PEER REVIEW REPORT

Lower East Coast subRegional Groundwater Flow Model and Draft Model Documentation

South Florida Water Management District

June 7, 2006

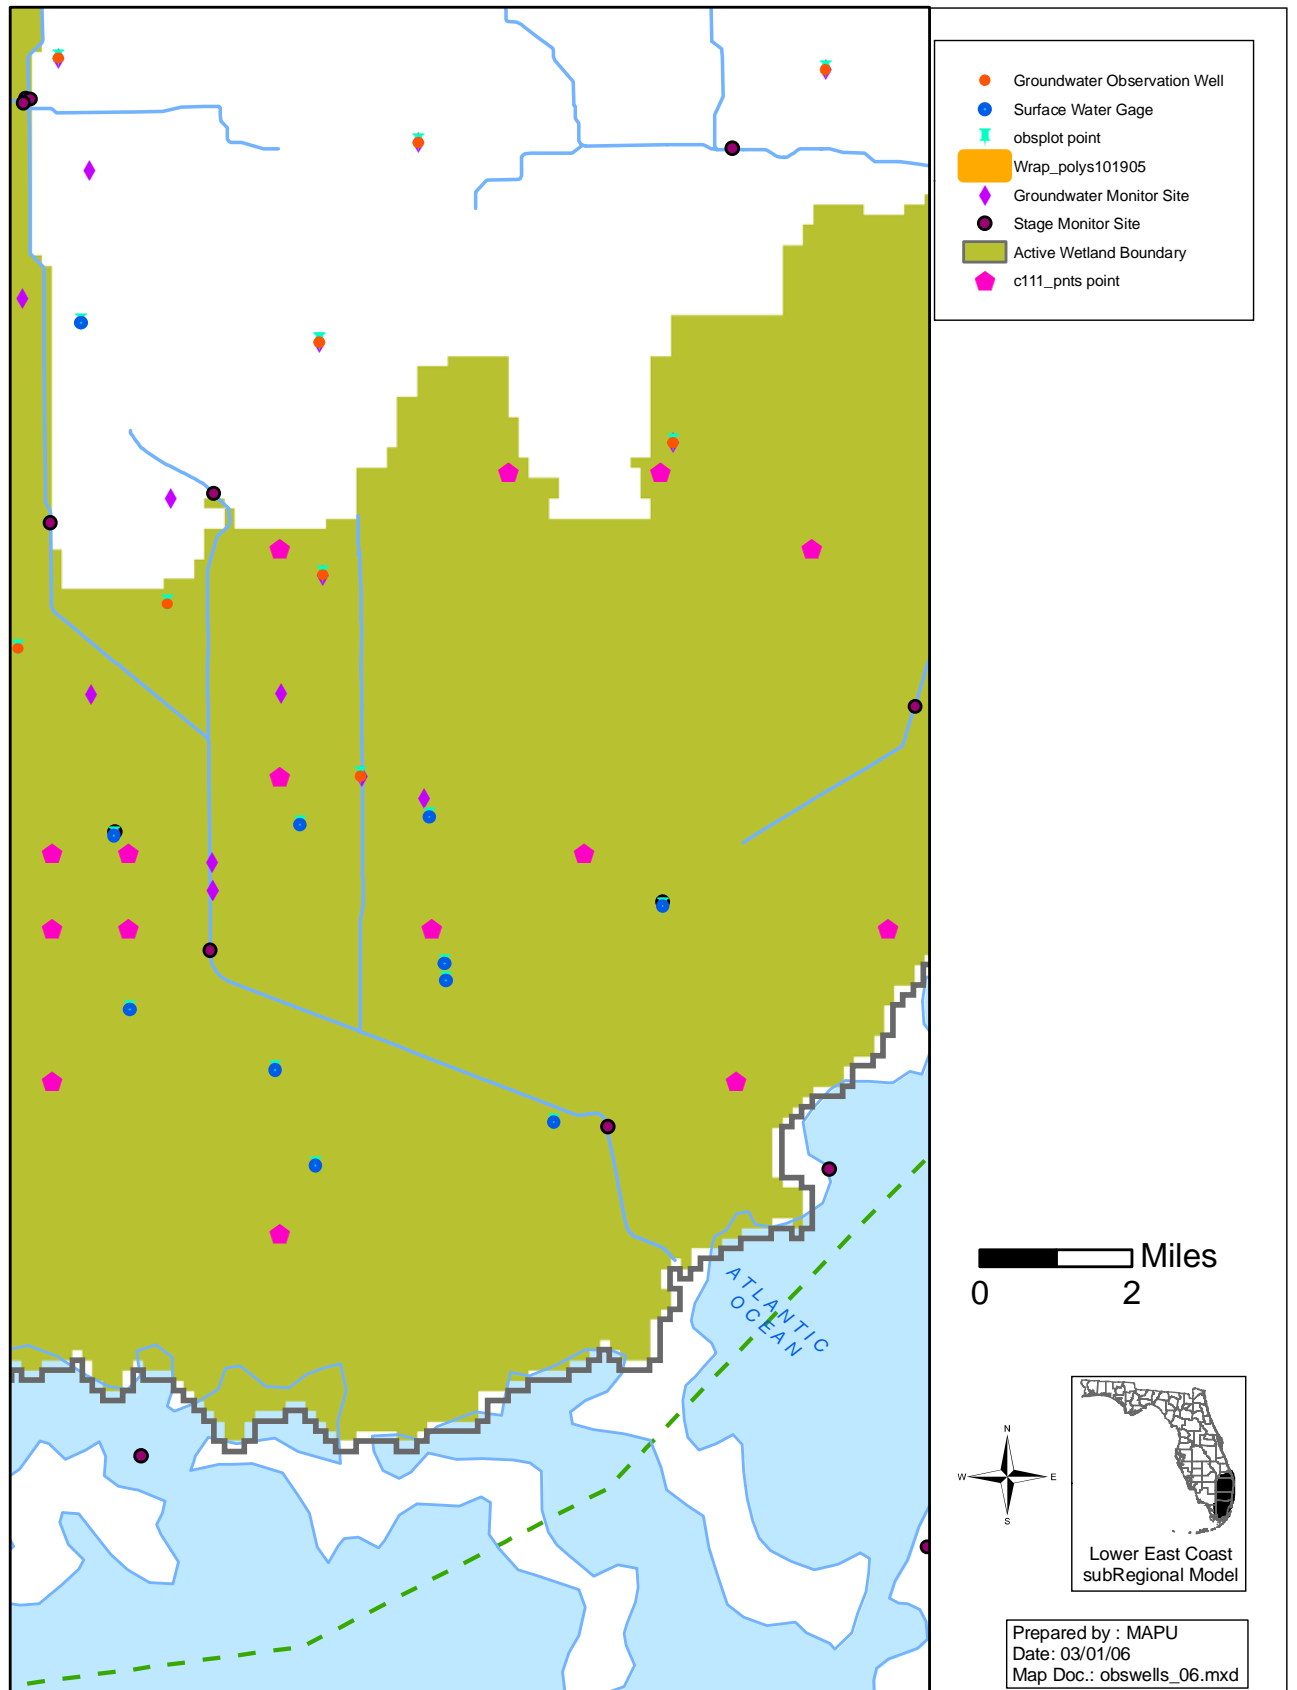
Comment / Question 202: Figure 78 indicates that in large areas of the model domain, particularly in the western half of the model, there are no observation wells or surface water gauges on which to base the quality of model calibration or to influence model calibration. How does the SFWMD address the non-uniform spatial distribution of model calibration target points? While the "global" criteria appear to be pretty well met, the spatial variability in target well and surface water gauge locations tends to beg the question of how well is the model really calibrated when there is fully half of the domain with no observed data on which to further judge the calibration. If the model is eventually used to address issues in these areas, will the SFWMD have the same level of confidence

in the model output as in areas where the calibration was pegged to a dense spatial distribution of observed measurements? In fact, overall the model could possibly be very sub-optimum (especially in the northern half of the domain) as it appears from Figure 78 that nearly half of all calibration target wells and surface gauges are in Miami-Dade County. The model could be significantly spatially biased due to the lack of uniform spatial coverage of calibration targets. What would be the calibration results if an attempt was made to remove many of the calibration targets in the southern half of the model so that there was more uniform spatial coverage of target wells? Could the overall quality of the model be improved by this exercise?

Response 202: There are a number of additional wells that were not included in the formal calibration. These include wells that are monitored with tape downs on a monthly or quarterly basis. The quality of this data is reasonable for some wells and questionable for other wells. Inclusion of these wells would greatly increase the number of observation wells in portions of Broward, Palm Beach and Martin Counties, particularly within the urban areas. In addition several other surface water gages are available in the Water Conservation Areas which were overlooked in the original data gathering process. The District is hesitant about removing observation wells from the calibration process to attempt to achieve a more uniform spatial coverage. The addition of these monthly or quarterly wells would be more advantageous than the removal of the wells in Miami-Dade County. However, this is a significant task and may require a fair amount of time to achieve. Regarding the EAA, we do not believe there is a single Surficial aquifer monitoring well anywhere within the area. The area is required to maintain Best Management Practices in order to minimize nutrient runoff. They comply with this by managing the water table at specific levels below ground surface. Perhaps a form of soft calibration can be utilized in this area by comparing water levels to the topography to understand the depth below ground surface and how well it compares to what the farms are operating the fields at.

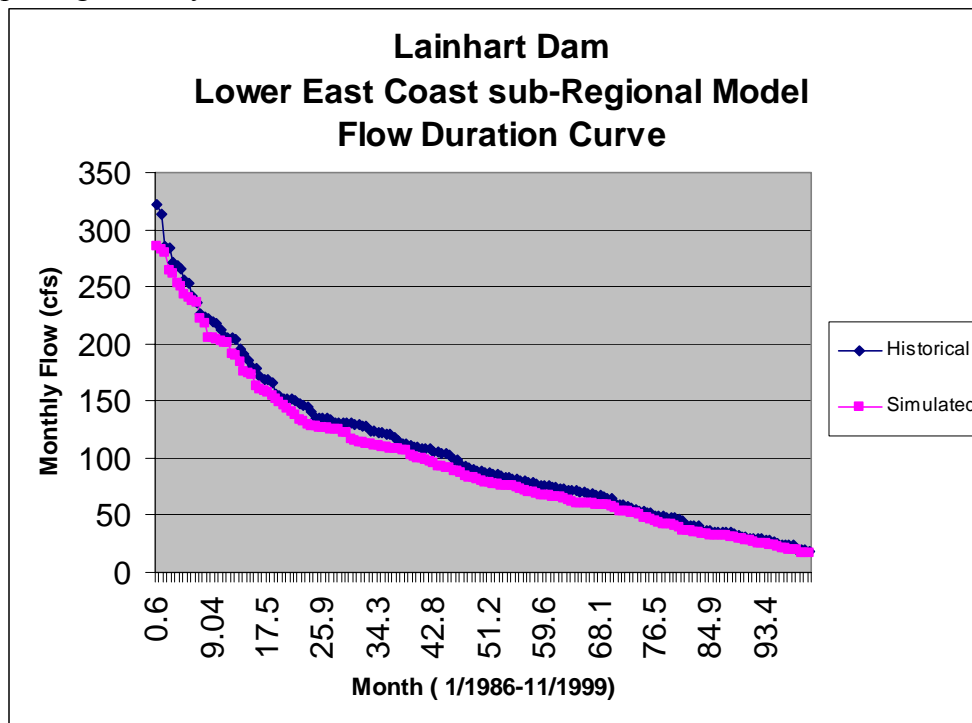
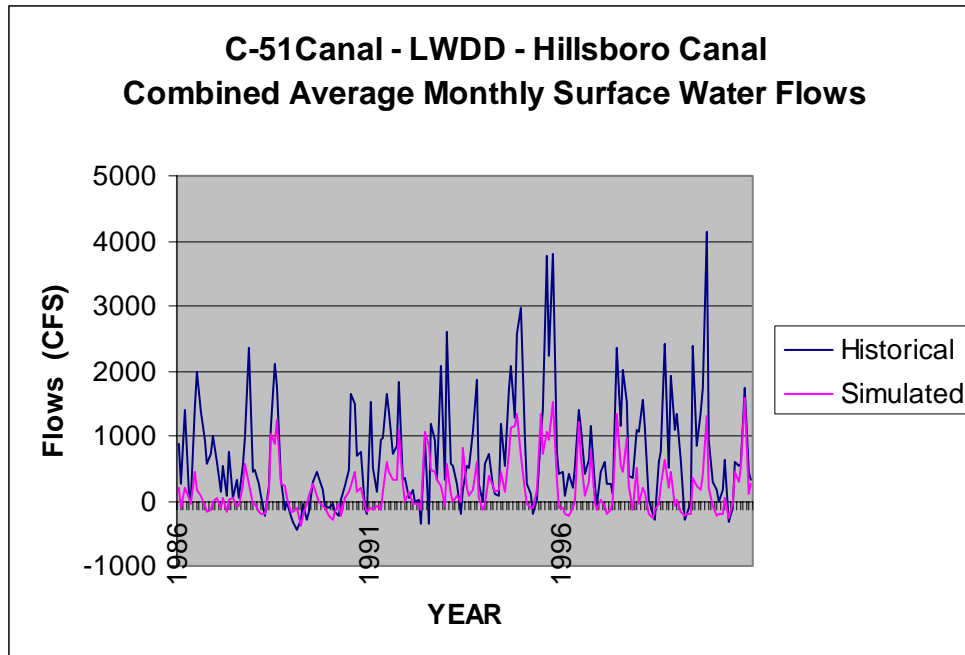
Comment / Question 216: Please report the accuracy of predicting all surface flows used in the calibration. Here, only flow in the C-18 canal is mentioned. Nowhere is found a list of all surface head and flow calibration locations. Please report all important surface flows that were not calibrated to.

Response 216: The model will be pseudo calibrated to flows for individual sub-basins within the model domain, where data is available. The only portion of the model calibrated to flows was the C-18 basin utilizing the wetland and diversion packages. The remainder of the model utilized the standard drain and river packages. Calibration to flows in these areas may require some modifications to the preprocessing of the recharge package to fully account for flows.

Average (1992) water levels(average daily water levels)

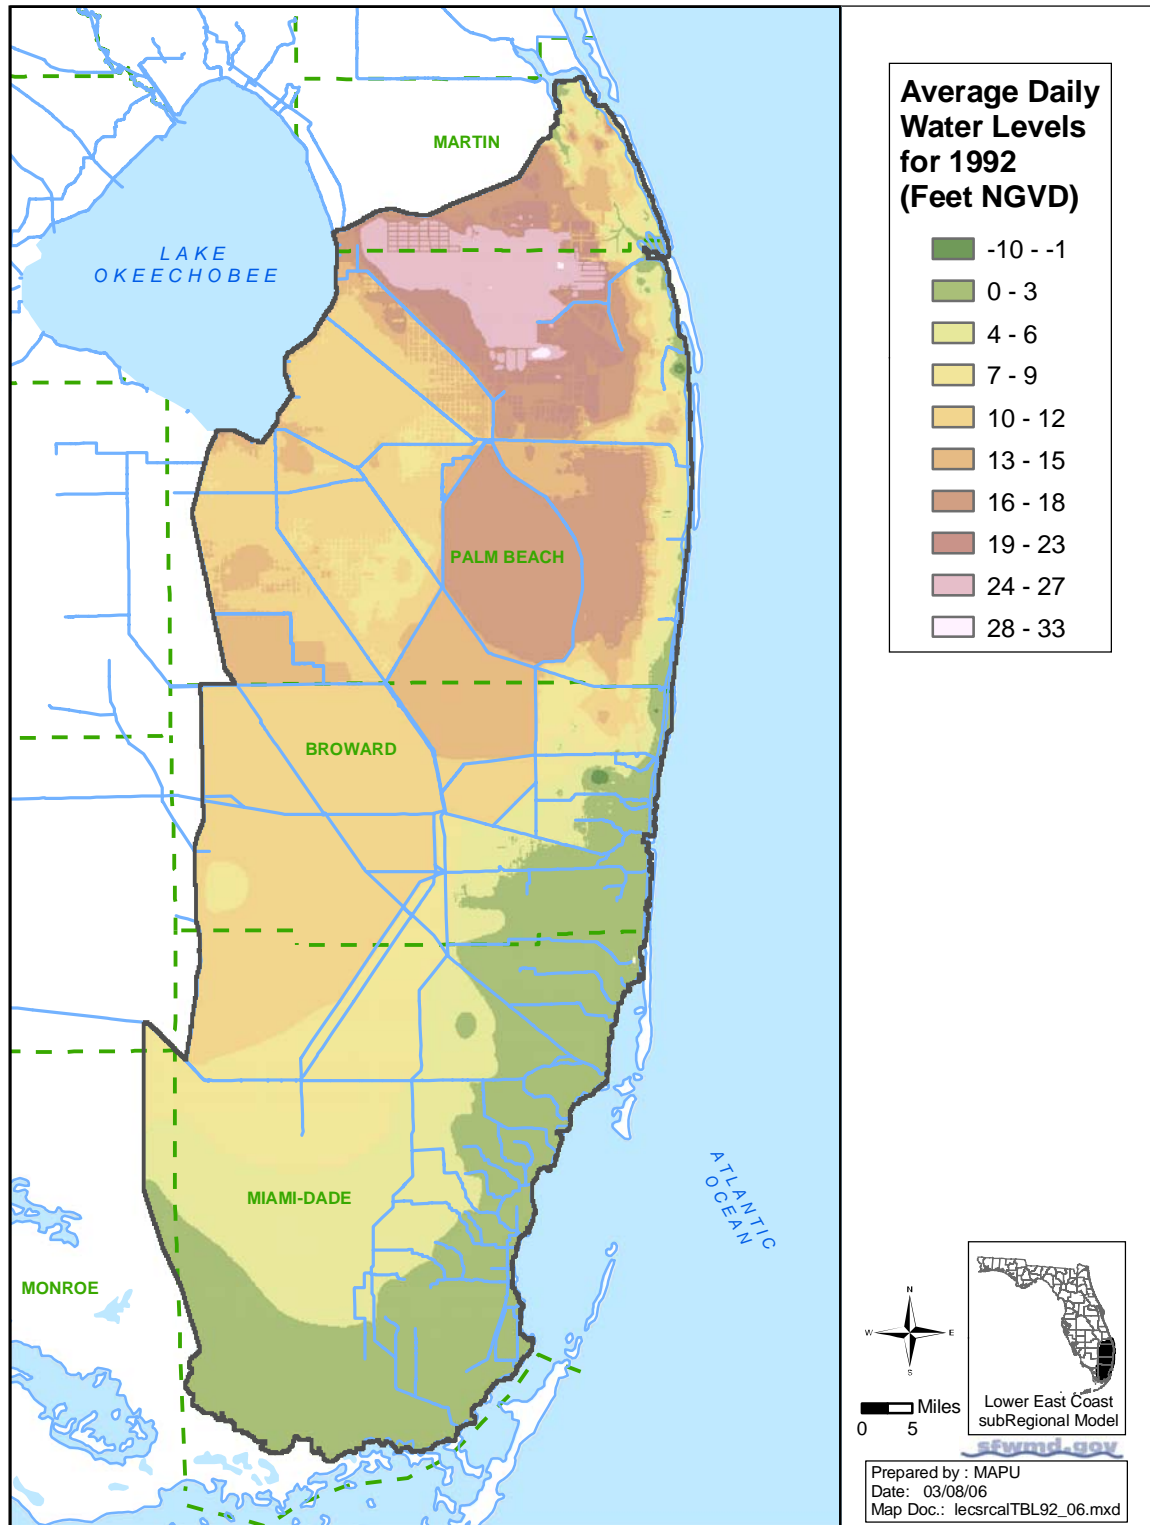
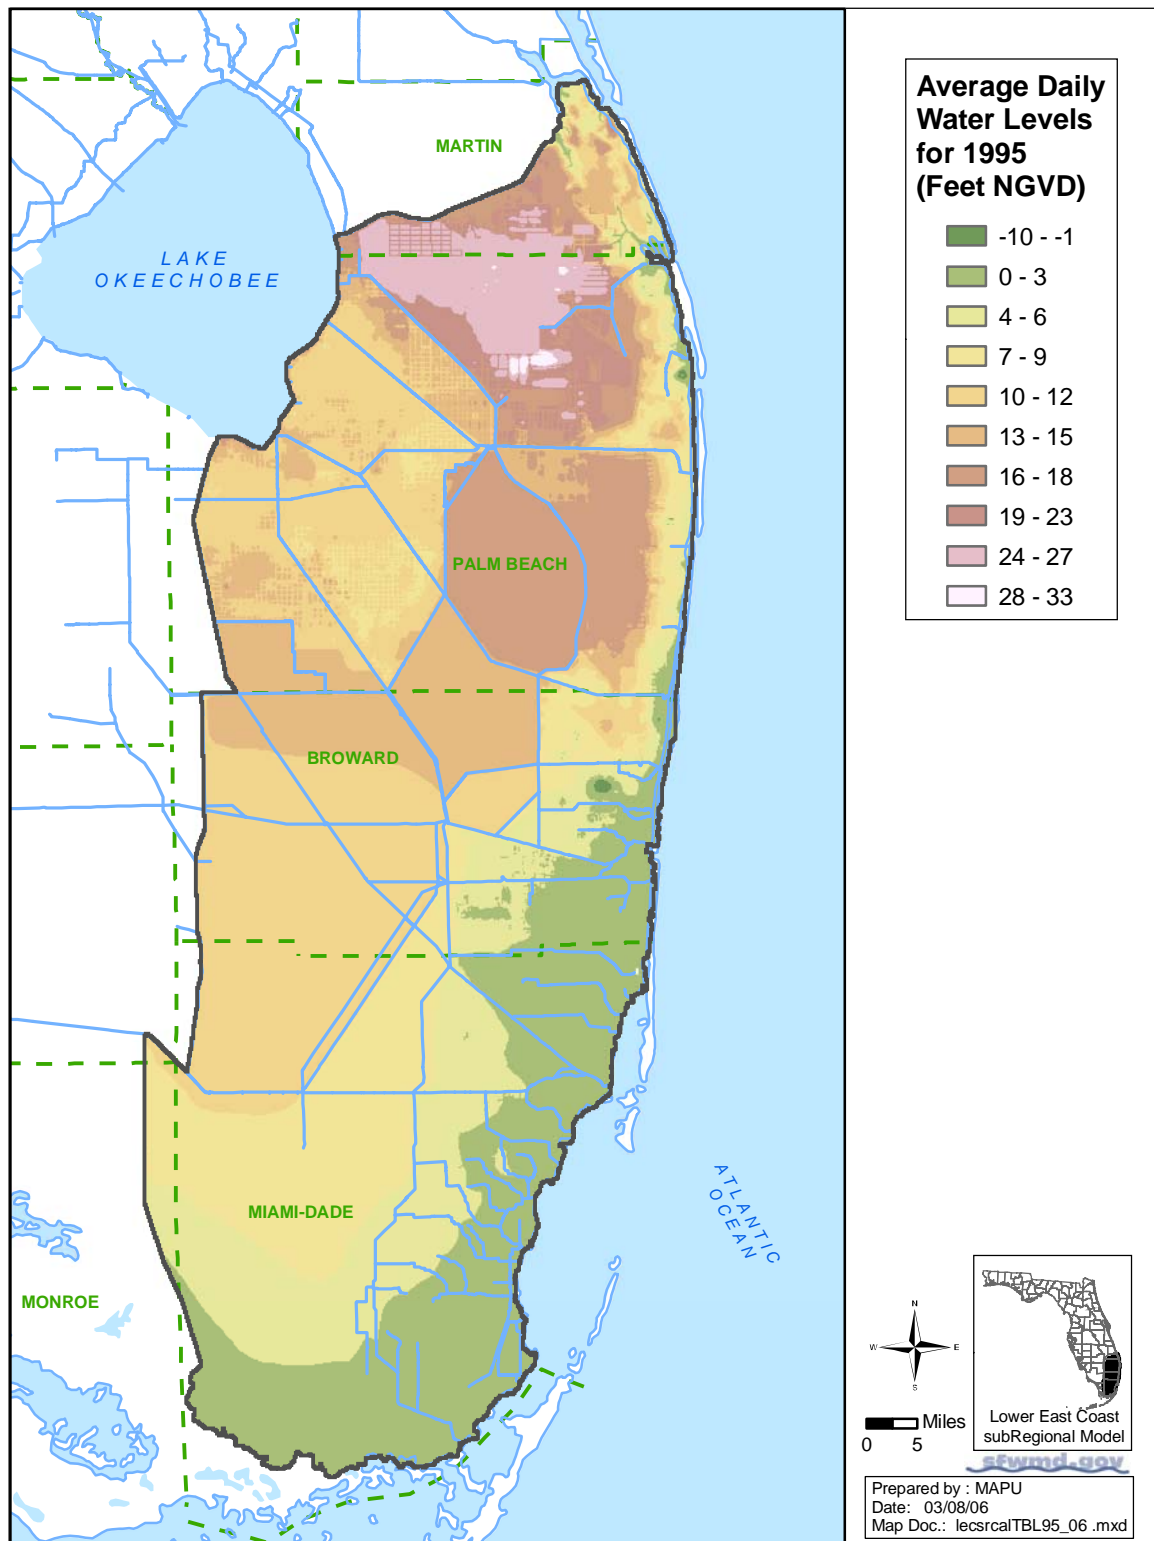
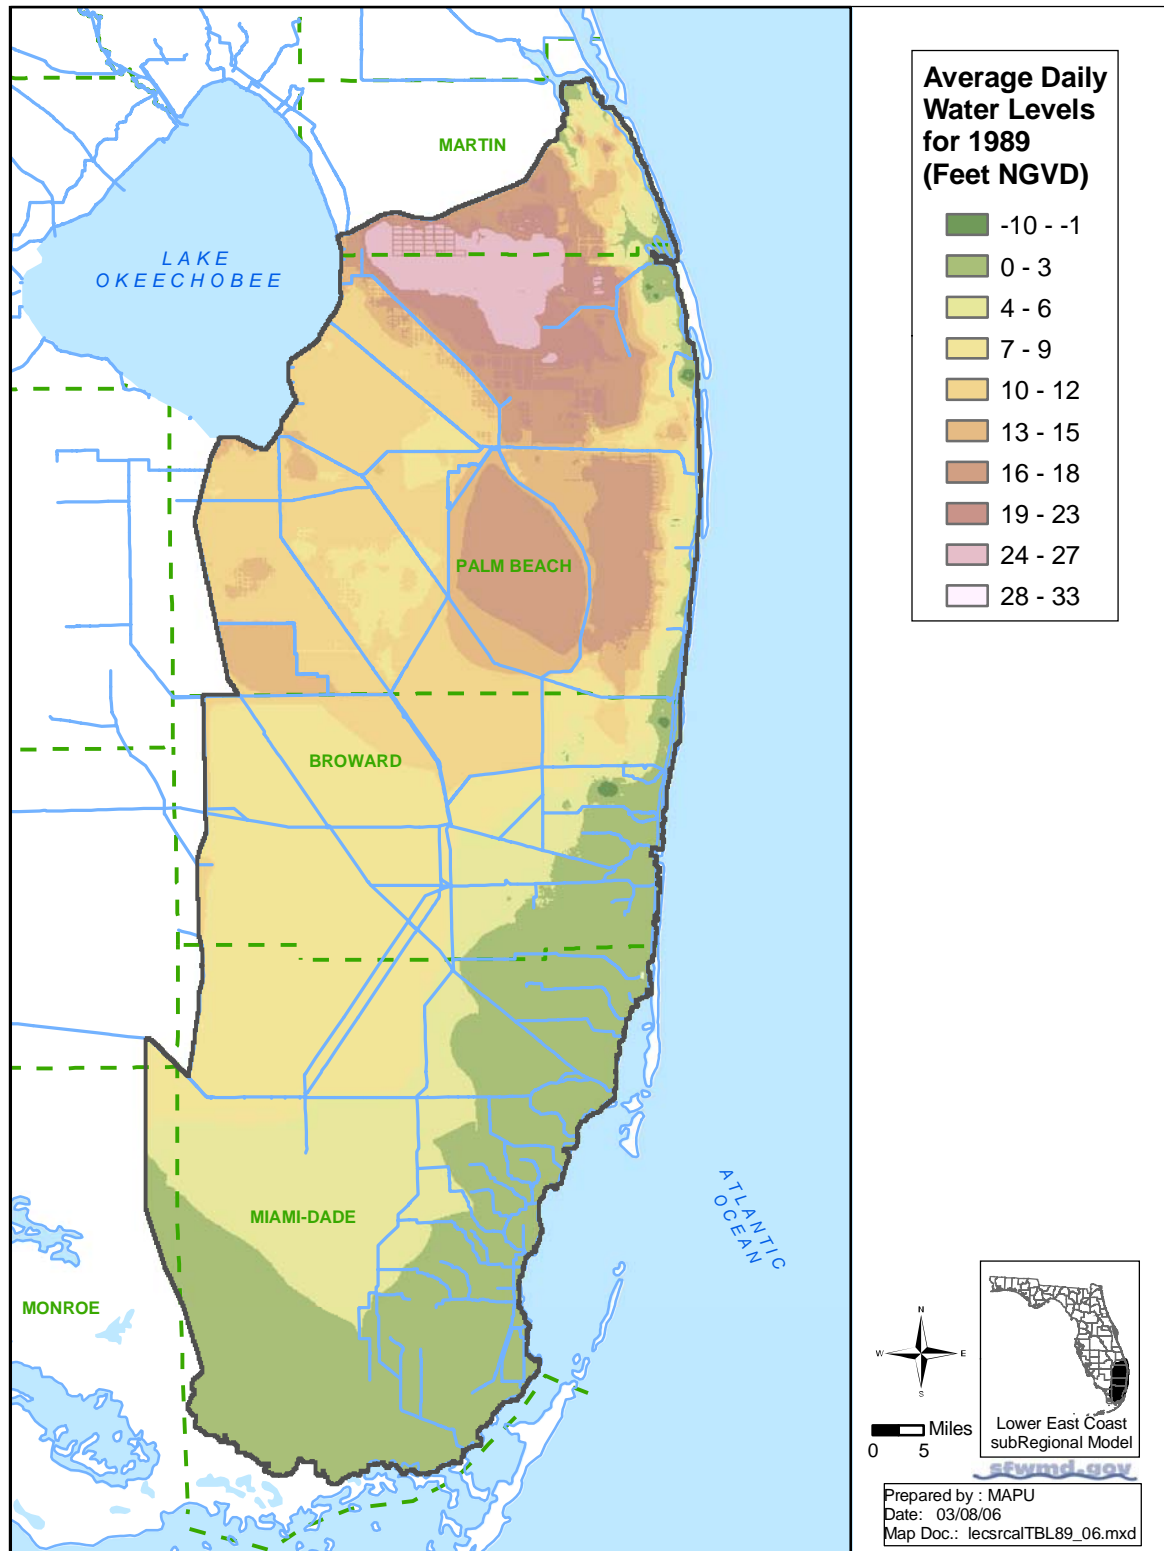
Comment / Question 217: It is stated that an intent is for the model to predict surface water flow directions properly. Provide evidence that it did so.

Response 217: We will provide evidence via the web board. Please see figures 83 through 85.
